Service Bulletin

Subject: Engine Oil Consumption on Aluminum Block/Iron Block Engines with Active Fuel Management (AFM) (Install AFM Oil Deflector and Clean Carbon from Cylinder and/or Install Updated Valve Cover)

Models: 2007-2011 Cadillac Escalade Models
2007-2011 Chevrolet Avalanche, Silverado 1500, Suburban, Tahoe
2010-2011 Chevrolet Camaro
2007-2011 GMC Sierra 1500, Sierra Denali, Yukon Models
2008-2009 Pontiac G8 GT
Built Prior to February 1, 2011 (Updated Valve Cover) and October 2010 (AFM Shield)
Equipped with Any of the Following Engines:
– Aluminum Block V8 Engine with Active Fuel Management (AFM) (RPOs L94, LZ1, L99, LC9, LH6, L76, LFA, L92)
– Iron Block V8 Engine with Active Fuel Management (AFM) (RPOs LMG, LY5)
– Hybrid Engine (RPO LFA – Only Applies to Hybrid Models Built July 7, 2009 - February 1, 2011 – Prior Builds Not Cast For AFM Valve)

This bulletin is being revised to update the Condition and modify the oil consumption test procedure. Please discard Corporate Bulletin Number 10-06-01-008E (Section 06 – Engine/Propulsion System).

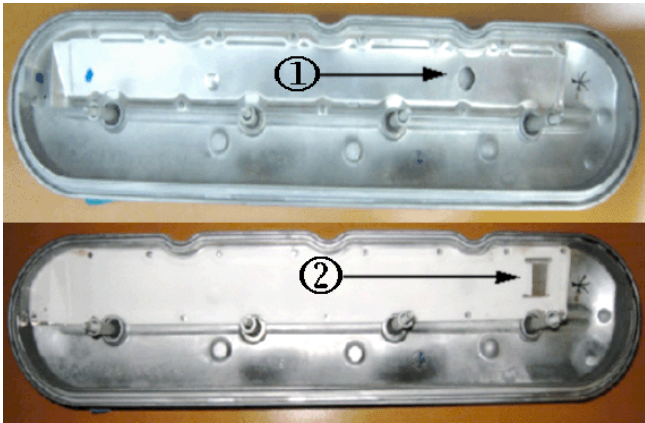
Aluminum or Cast Iron Block - Oil in Intake Manifold - Install Updated Valve Cover on All Models Built Prior to February 1, 2011

1) Old Design

2) New Design

PCV pullover or an overactive lifter can cause oil to be pulled through the PCV system even at low vehicle mileage. A correctly functioning PCV system will only leave a film of oil in the intake manifold. Inspect the intake manifold to see if there is any oil puddling in the bottom. If there is you will need to replace the left valve cover. Two new left rocker arm covers have been released for trucks and vans. Technicians should replace the left rocker arm cover with GM P/N 12570427 for 2007-2008 or GM P/N 12642655 for 2009-2011. Refer to the Parts Information below for the Camaro. This rocker arm cover has a relocated PCV drain hole that prevents oil from entering the intake manifold. Refer to Valve Rocker Arm Cover Replacement - Left Side in SI.

Note: These rocker covers are for specific years. The PCV orifice is different for each. The correct cover must be used or an SES light may set.

Aluminum Block - Oil Getting Past Piston Rings - Free Up Piston Rings and Install AFM Shield on All Non-Hybrid Models Built Prior to October 1, 2010 or all Hybrid Models Built July 7, 2009 - October 1, 2010

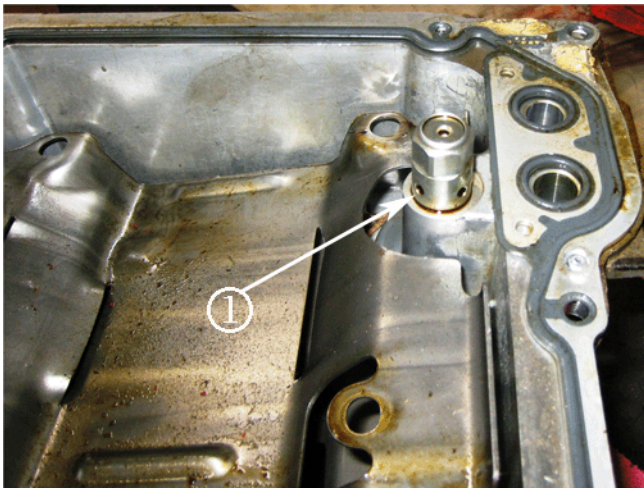
Note: If vehicle is built outside of this breakpoint, it should already be equipped with this AFM shield or the pan does not have an AFM valve (LFA before July 7 2009).

To correct this condition, install an AFM shield, perform the piston cleaning procedure as described in this document and install a new oil pan gasket per the procedure outlined in this document. Monitor oil consumption after this repair to ensure oil consumption has improved to acceptable levels.

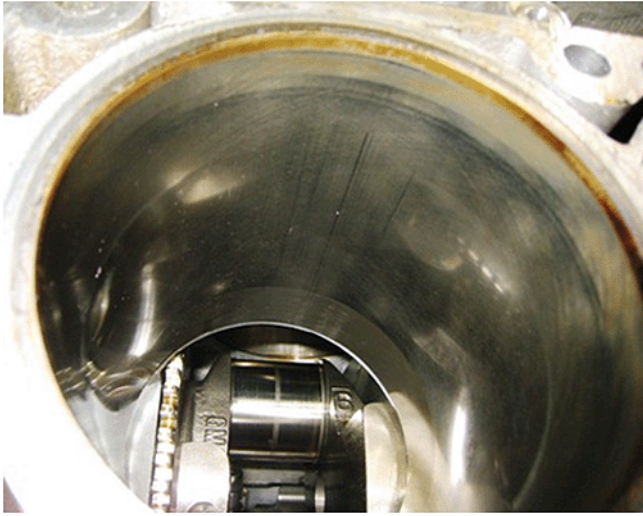
4. Remove the AFM valve (1).

5. Install the new shield (1), GM P/N 12639759, and tighten the AFM valve to the oil pan to 28 Y (20 lb ft).
